# **PLANNING PANELS VICTORIA AMENDMENT C230 WHITEHORSE PLANNING SCHEME**

Statement of Town Planning Evidence  
prepared by Andrea Pagliaro

Prepared for  
**NORTON ROSE FULBRIGHT**  
20 January 2023

Figure 1 - Concept Plan

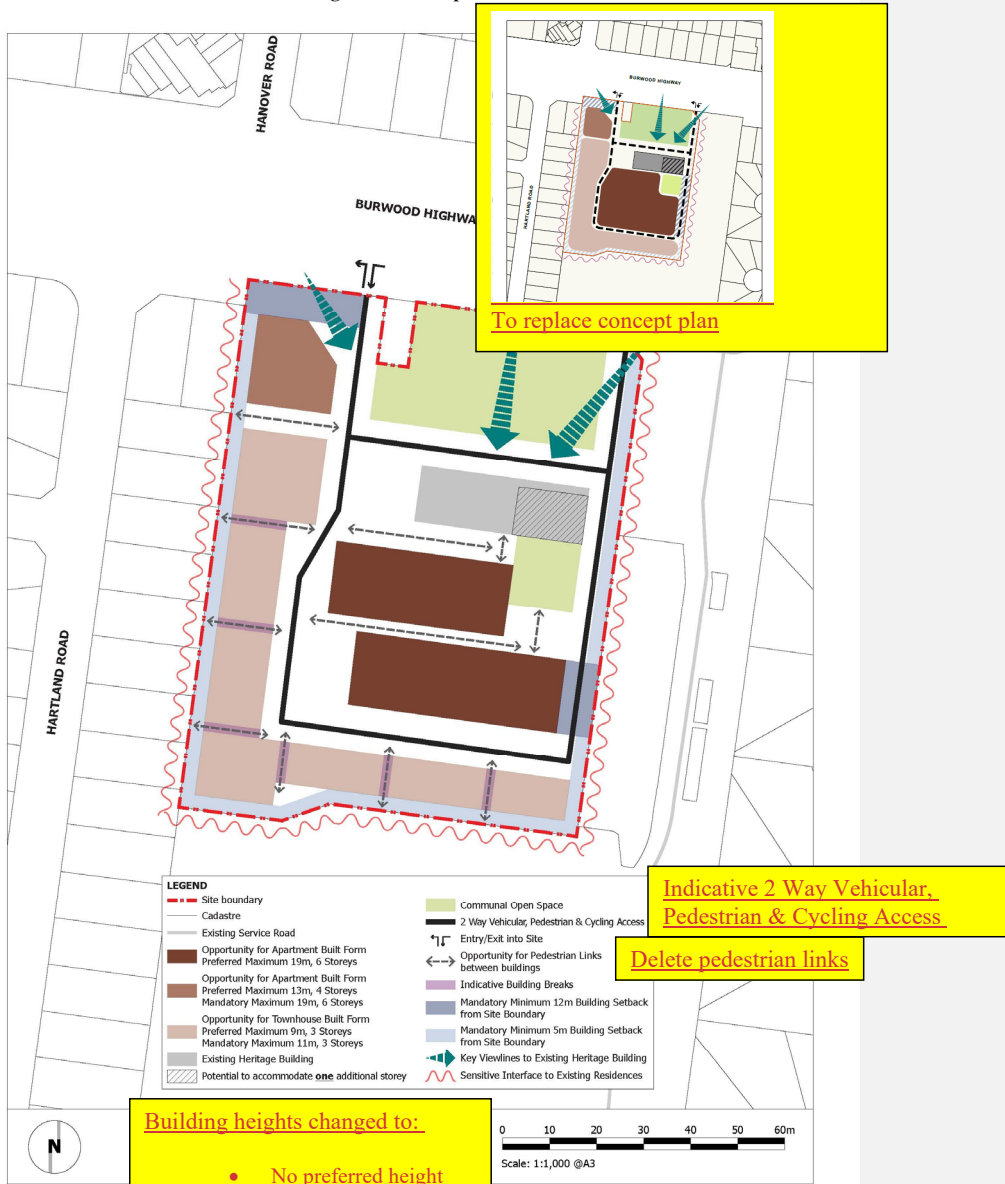
72. Turning to the concept plan, I have the following concerns with the current version (in addition to those raised above):

- The plan presentation appears to designate building envelopes which raises the question of the uncoloured (white) areas and what is intended for those spaces.

Delete pedestrian links

73. My recommendations are contained within a marked up version of Schedule to the DDO at Appendix C.
74. I have been provided with an updated concept plan prepared by Ms Bell. This version addresses my concerns and I support its replacement in the DDO6. I agree with Ms Bell that the building envelope areas should be replaced with building height and typology areas. The current concept plan has the potential to stifle an architect's ability to produce the best design outcome, which may not be confined to the proposed building envelopes. The currently proposed apartment building envelopes are not considered optimal for achieving ESD outcomes given the proposed east-west orientation of the building blocks, which would result in a significant number of south facing apartments. I also support Ms Bell's recommendation in relation to the townhouse areas to require 3 physical breaks along each of the western and southern boundaries in the requirements of DDO6 rather than shown on the concept plan. This will achieve the same desired outcome in terms of building breaks but provide greater flexibility in the final location of the breaks. Overall, I consider Ms Bell's concept plan, which provides greater flexibility whilst retaining certainty through retaining height and setback controls, provides the preferred planning framework for the site.
